DEVIATION REQUEST AND DECISION FORM

Project Name : Homestead North at Sterling Ranch Filing No. 3
 Schedule No.(s) : 5228000030 and 5228000038
 Legal Description : See Exhibit B – Legal Description

A deviation from the standards of or in Section **ECM section 2.3.2 Design Standards** of the Engineering Criteria Manual (ECM) is requested for the Poco Rd and Aspen Valley Intersection K value.

ASPEN VALLEY ROAD PROFILE (3) STA 15+00.00 TO 18+29.41

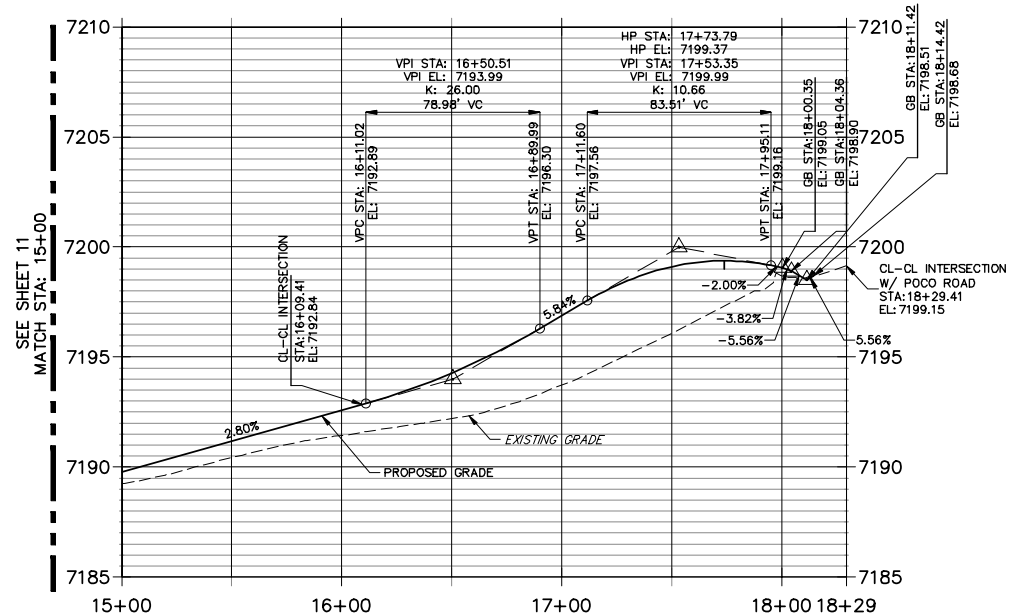
Per ECM Section 2.3.4, Table 2.12, a design speed of 25 MPH would require a K value of 12 on the Aspen Valley crest vertical curve approach to Poco Road.

Per the roadway design for Aspen Valley, the K value of the crest vertical curve is 10.66.

See Exhibit A for a representation of the Aspen Valley approach to Poco Road.

Aspen Valley Road is a urban local road providing Poco Road access to the residential lots within Homestead North at Sterling Ranch Filing No. 3. The natural topography of the area slopes south east which requires Aspen Valley Rd. to rise substantially to meet Poco Road existing grade. Poco Road is a rural road with roadside ditches and its drainage design is to keep the ROW stormwater flows draining east to Sand Creek. To maintain this drainage concept, a crest vertical curve was placed near the intersection. The proximity of the crest vertical curve to the intersection necessitated shorter vertical curve with a K value of 10.66 versus the ECM standard of 12.

There is a 5.84% rising slope in Aspen Valley followed by a 2% downslope to Poco. The vertical curve was placed as close to the intersection as practical, to lessen the fill requirements.

Aspen Valley is stop controlled at Poco Road.
